COTTAGE HILL NURSERY SUBDIVISION

DETAIL SITE PLAN

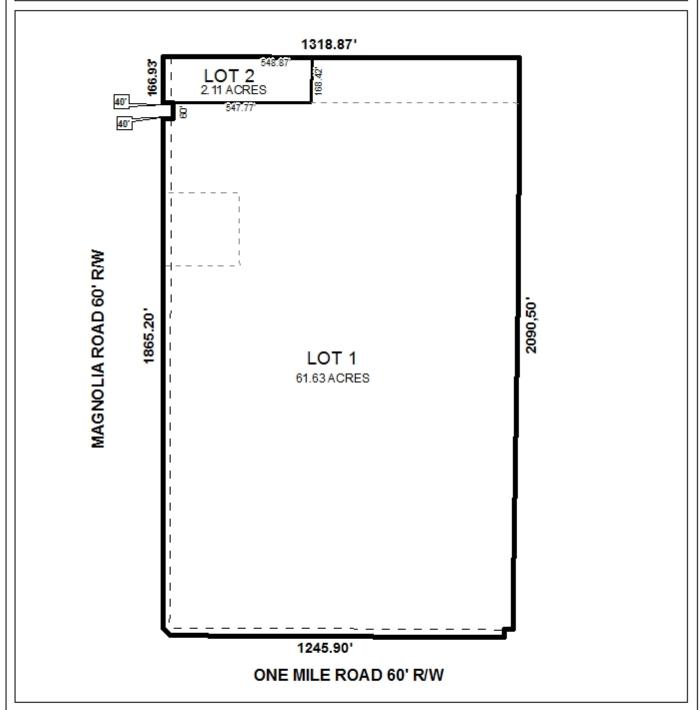
In accordance with the Subdivision Regulations, both proposed lots of the current application are compliant with the minimum size requirements; however, the proposed Lot 2 would require a waiver of Section V.D.3. for approval due to its depth-to-width ratio. The 25-foot minimum building setback line and the lot sizes in square feet are illustrated on the preliminary plat and should be retained on the Final Plat if approved.

The proposed Lot 1 has 5 existing curb-cuts along Magnolia Road and 2 existing curb-cuts along One Mile Road. The proposed Lot 2 has one existing curb-cut along Magnolia Road. As a means of access management, a note should be placed on the Final Plat limiting both lots to the existing curb-cuts, and one additional curb-cut allowed for Lot 1 along One Mile Road. The size, design and location of the additional curb-cut along with any changes to the existing curb-cuts are to be approved by Mobile County Engineering and conform to AASHTO standards.

This site is located in the County, and therefore any lots which are developed commercially and adjoin residentially developed property must provide a buffer, in compliance with Section V.A.8. of the Subdivision Regulations. It appears that a portion of the proposed Lot 1 is already commercially developed and as a result, a buffer should be provided where the proposed lot abuts residentially developed property. Notes regarding these requirements should appear on the Final Plat if approved.

- 1) Retention of the lot size information and the 25-foot minimum building setback line on the Final Plat;
- 2) Dedication of a corner radius at the intersection of Magnolia Road and One Mile Road to comply with AASHTO standards and be approved by Mobile County Engineering;

- 3) Placement of a note on the Final Plat limiting both lots to the existing curb-cuts, with one additional curb-cut for Lot 1 along One Mile Road. The additional curb-cut and any changes to the existing curb-cuts to be approved by Mobile County Engineering and conform to AASHTO standards;

- 4) Depiction of a buffer of Lot 1 where it abuts residentially developed property;
- 5) Compliance with Engineering Comments and placement of a note on the Final Plat stating: (Must comply with the Mobile County Flood Damage Prevention Ordinance. Development shall be designed to comply with the storm water detention and drainage facility requirements of the City of Mobile storm water and flood control ordinances, and
